<p>GUNNISON VALLEY HOSPITAL - NEGATIVE PRESSURE ROOMS REMODEL</p> <p>ADDENDUM # 1</p>	<p>Date: October 8, 2020</p>
---	-------------------------------------

Electrical Addendum #1

Date: October 8, 2020
To: Kris Bown
Company: Design West
Job: Gunnison Valley Hospital Negative Pressure Rooms
Job No: 200473
Cc:

3 LEVEL 1 LIGHTING PLAN
SCALE: 1/8" = 1'-0"

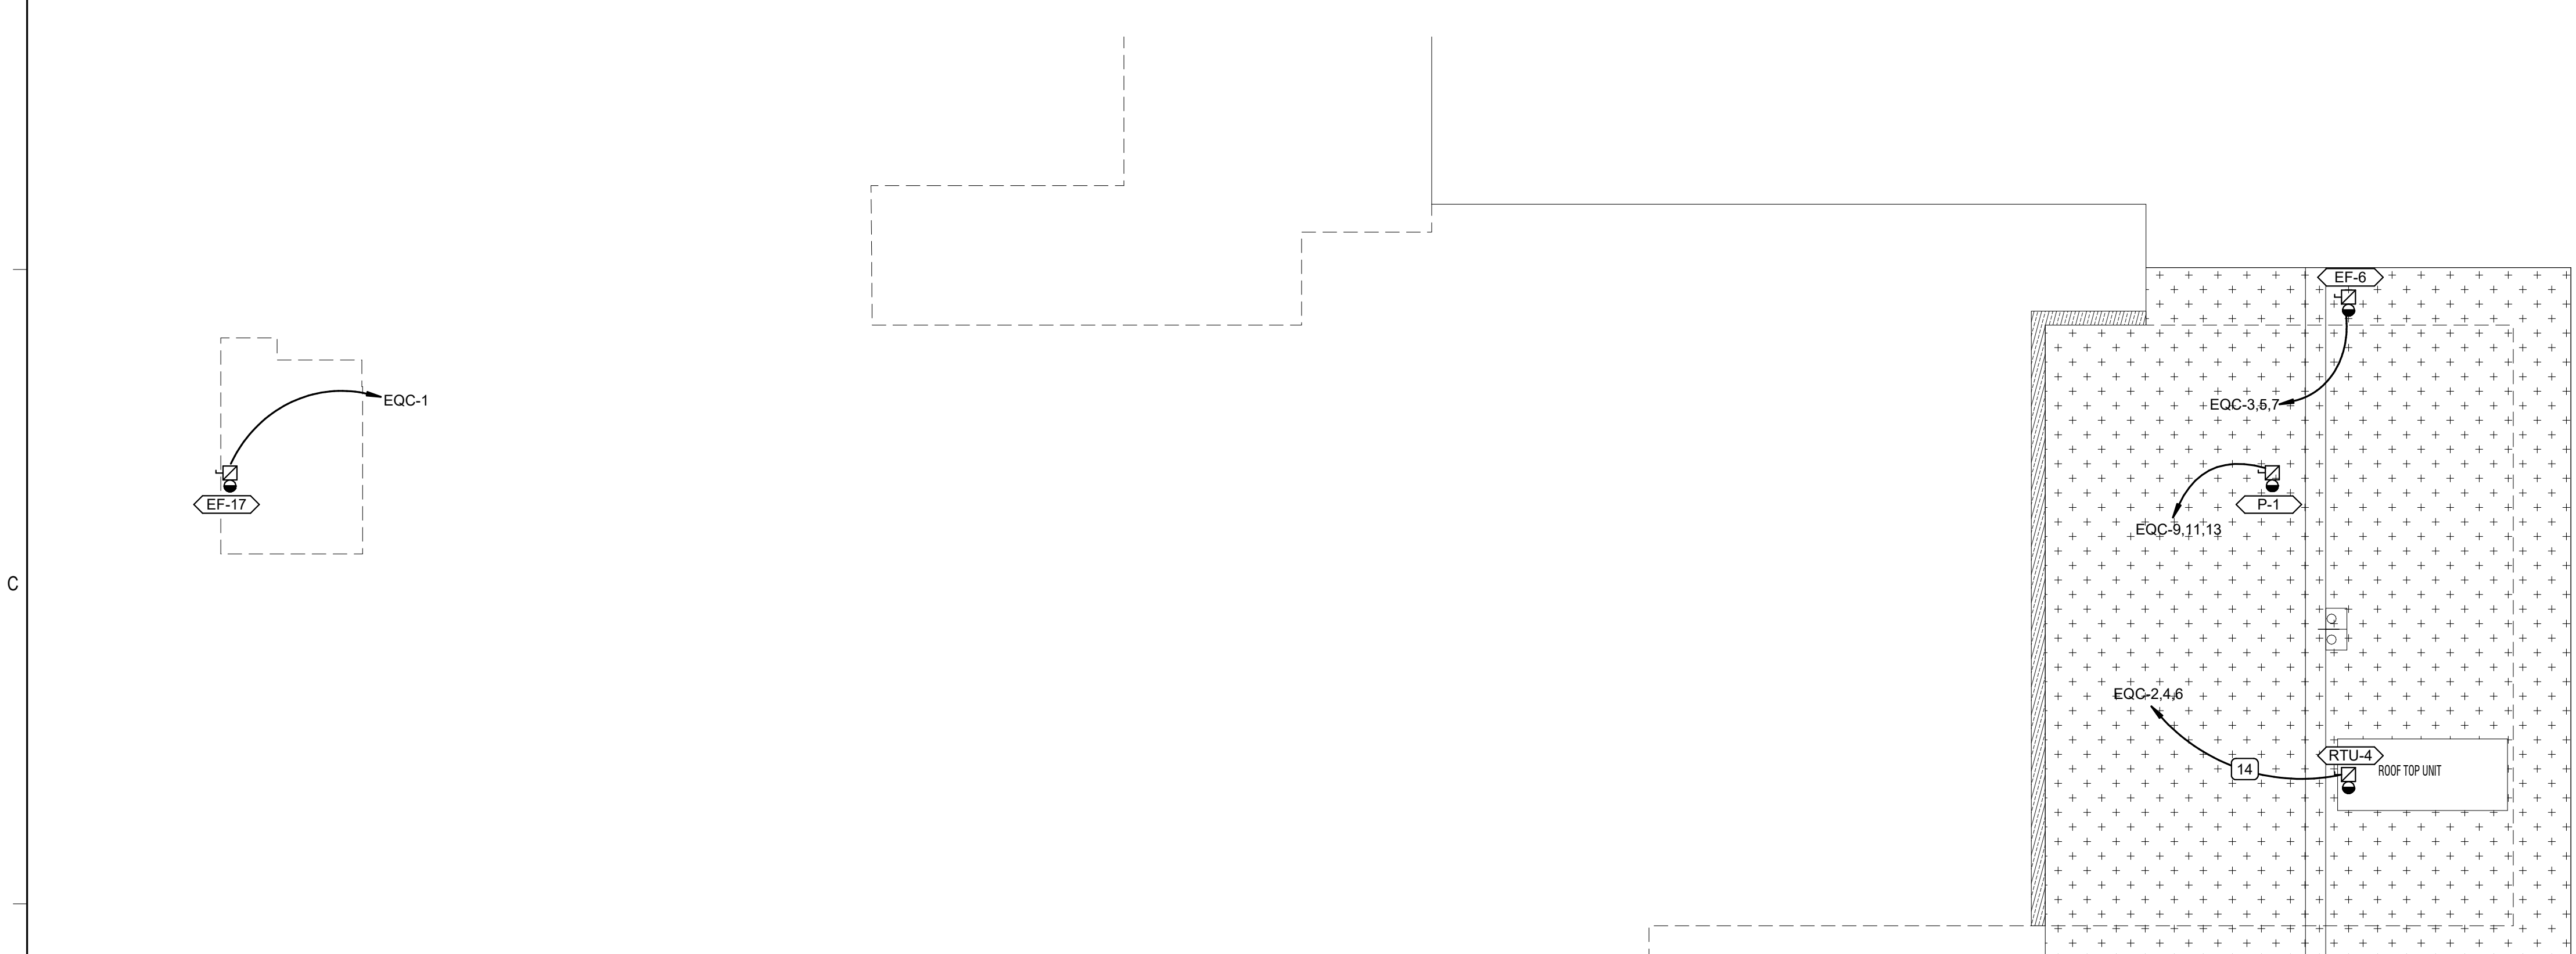
1. EP101 – Lighting Plan
 - a. Revised switching to allow for pillow speaker control of the ambient and reading lights.
2. EL601 – Lighting Schedules

- 1 PROVIDE THREE FUNCTION 2x4 RECESSED PATIENT FIXTURE. CONTROL ZONE "a" IS THE AMBIENT LIGHTING, CONTROL ZONE "b" IS THE READING LIGHT AND CONTROL ZONE "c" IS THE EXAM LIGHT.

- 5 BORE FOR NEW CONDUIT FROM BASEMENT ELECTRICAL ROOM TO CRAWLSPACE.
- 6 PROVIDE CURBELL LVC-2000 LOW VOLTAGE CONTROLLER TO ALLOW FOR PATIENT TO CONTROL LIGHTING IN THE ROOM WITH THE PILLOW SPEAKER. ZONE a WILL BE CONTROLLED BY THE PILLOW SPEAKER AND A MOMENTARY DIMMER BY THE DOOR. ZONE b WILL BE CONTROLLED BY JUST THE PILLOW SPEAKER. ZONE c WILL BE CONTROLLED BY THE PILLOW SPEAKER AND BY A MOMENTARY SWITCH BY THE DOOR. CONTROLLER SHALL BE LOCATED IN AN ACCESSIBLE LOCATION, COORDINATE EXACT LOCATION WITH OWNER.

LIGHTING SCHEDULES

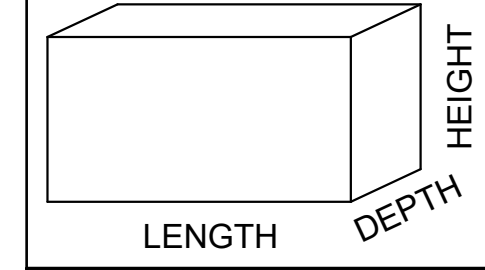
Electrical sheet E101 detail has a fixture OJ-1 shown on the wall of the patient area on the wall opposite the toilet room. this fixture is not noted in the Light Fixture Schedule. Please have electrical engineer provide fixture number for this.

- a. Added fixture type OJ-1.
- b. Added additional approved manufacturers.
- c. Added anti-microbial finish to the UC-5 fixture.

This will be a recessed night light, Refer to the updated drawings in this addendum for fixture specification.

(OJ-1)	LED NIGHTLIGHT, RECESSED IN WALL, AMBER, WHITE GLOSS FINISH, TORX HEAD WITH CENTER PIN FASTENERS, HIGH IMPACT ACRYLIC LENS	-	-	-	-	WR	LED	AMBER		NO DIMMING	120/277	5	WH	150						KENALL (MCSL-HR-MW-2LAMB-DV)	HEALTHCARE (HNL610-MV-LED-AMB-TR-FW)	NEW STAR (HPT624-F-UNV-PAILED4-0-FC100-LVD-1G-DIM-AM-SL)	VISA (CM1946)
(VPE-1)	24" W RECESSED FLANGE MOUNT AMBENT READING AND EXAM LIGHT WITH 2 DIRECTIONAL READING LIGHTS, INGRESS BARRIER DOOR, ANTIMICROBIAL FINISH ON EXPOSED SURFACES, 1400 LUMEN EXAM LIGHT, 4000 LUMEN AMBIENT LIGHT	2'-0"	-	-	-	CR	LED	3500K		0-10V DIMMING (1%)	120/277	135	-	11000						KENALL (MPCADE24-F-45L/90L40K-DCC-DV-1B-AC-AMF-LRL)	NEW STAR (SMDOS-F-24-HC-L340-L2-40-RL-UN)	HEALTHCARE (HPT624-F-UNV-PAILED4-0-FC100-LVD-1G-DIM-AM-SL)	VISA (CM1946)
(UC-5)	24" LED UNDERCABINET LIGHT (ANTIMICROBIAL FINISH)	2'-0"	-	-	-	S	LED	3500K		NO DIMMING	120/277	8	-	600						DAY-BRITE (LINC3100E-L28-935-UNV-WHG-DIM)	KENALL (AUCLED)	KELVIX (UC22)	FAIRY-THOMPSON (13MC)
